CITY OF CARMEL-BY-THE-SEA HISTORIC RESOURCES BOARD

REGULAR MEETING Monday, October 16, 2023

SUBJECT: **DR 23-233 (128 S Canon, LLC):** Consideration of a Track 1 Design Review referral, DR 23-233 (128 S Canon, LLC), for storefront modifications to an existing non-historic building location on Ocean Avenue 2 northwest of Mission Street in the Central Commercial (CC) District and Downtown Conservation (DC) District Overlay. APN: 010-113-007-000.

Figure 3. Proposed Tile Mural to be located on 2nd floor facing Ocean Avenue.

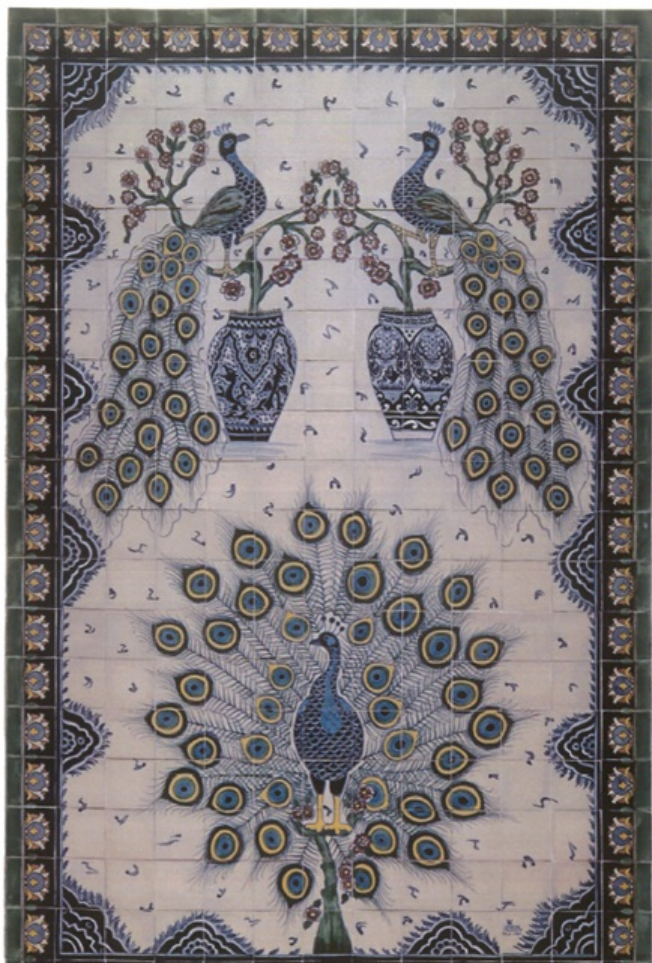
The mosaic would be a new addition to the Conservation District as to staff's knowledge there are no large tile mosaics within the boundaries of the conservation district. However, art displays on, or adjacent to buildings are part of the established context of the Conservation District including: The Carmel Shell mural, the Bill Bates mural, the Charlie Chaplin mural, and the California Del Norte mural. While the aforementioned murals are all painted murals, the subject mural would be the first tile mural.

APPROVED - OCEAN AVENUE ELEVATION W/ STOCK COLOR DECO TILE - 7/14/2023
REV. 1: 7-21-23. WAINSCOT TILE COLOR CHANGE; PEACOCK TILE MOSAIC; TILE OVER TWO DOORS

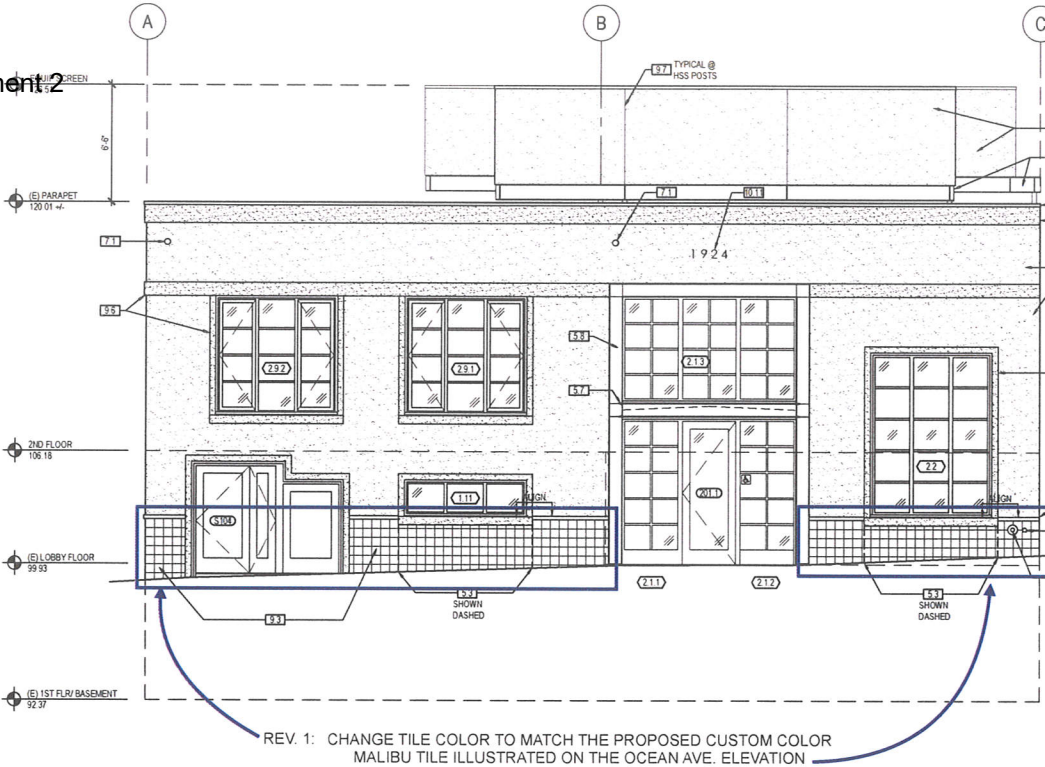
REV. 1: 7-14-23. WAINSCOT TILE COLOR CHANGE;
PEACOCK TILE MOSAIC; TILE OVER TWO DOORS

PROPOSED: ADD 72" X 96" HAND PAINTED TILE BY FAMOUS MEXICAN MURALIST.

PROPOSED: 18" X 18"
TILE ACCENT W/
APPROVED TILE
COLOR.

South Exterior
Elevation
SHEET NUMBER:
A3.2

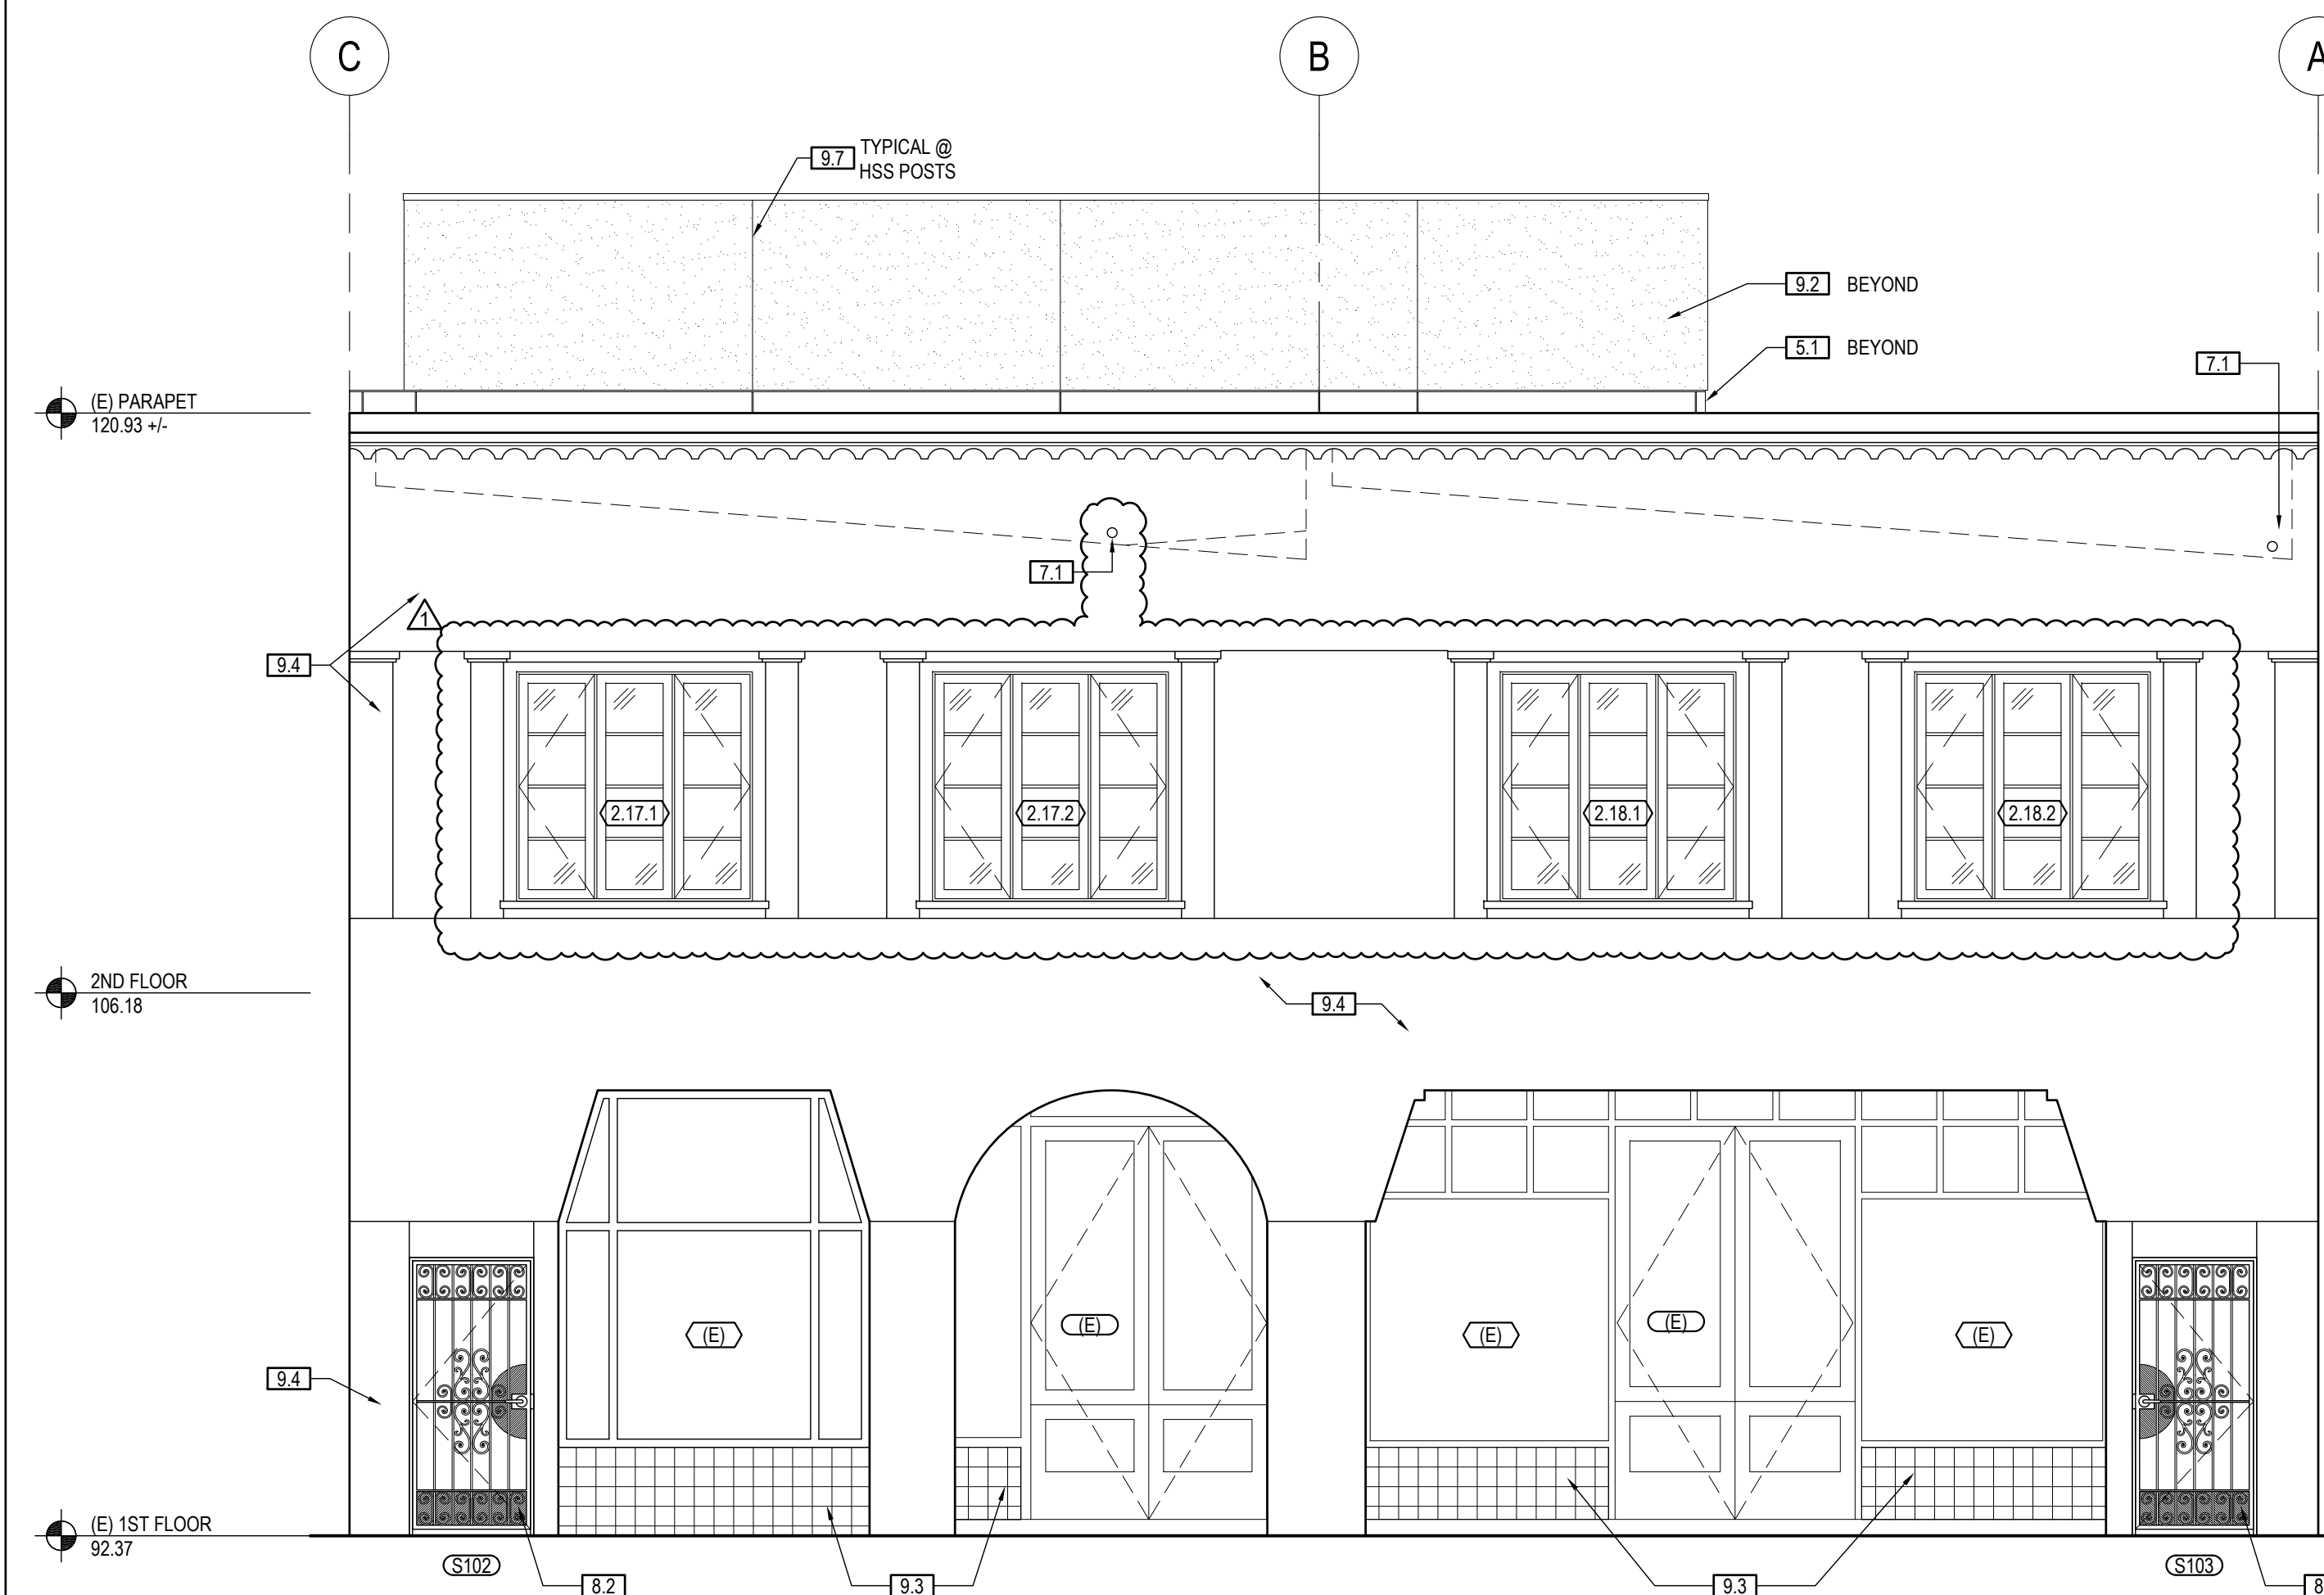
- 2.5 REMOVE DOOR & FRAME
- 2.8 CORE DRILL EXISTING CONCRETE WALL AS REQUIRED TO INSTALL NEW OVERFLOW SCUPPER
- 2.45 REMOVE STONE VENEER. PREPARE SURFACE TO RECEIVE NEW TILE.
- 5.1 PAINTED STEEL BEAM. SEE STRUCTURAL DRAWINGS.
- 7.8 PAINTED GALVANIZED SHEET METAL COPING
- 8.2 CUSTOM FABRICATED PAINTED STEEL GATE AS SCHEDULED.
- 9.2 EQUIPMENT SCREEN: PAINTED THREE-COAT PORTLAND CEMENT PLASTER ON EXPANDED METAL LATH OVER (2) LAYERS OF 60 MIN. GRADE 'D' BUILDING PAPER, STUCCO SHALL HAVE A SMOOTH STEEL-TROWELED FINISH.
- 9.3 CERAMIC TILE & CAP MOLDING AS SPECIFIED.
- 9.4 PAINT EXISTING STUCCO
- 9.7 PAINTED GALVANIZED STEEL STUCCO CONTROL JOINT: STOCKTON PRODUCTS M SCREED OR EQUAL.
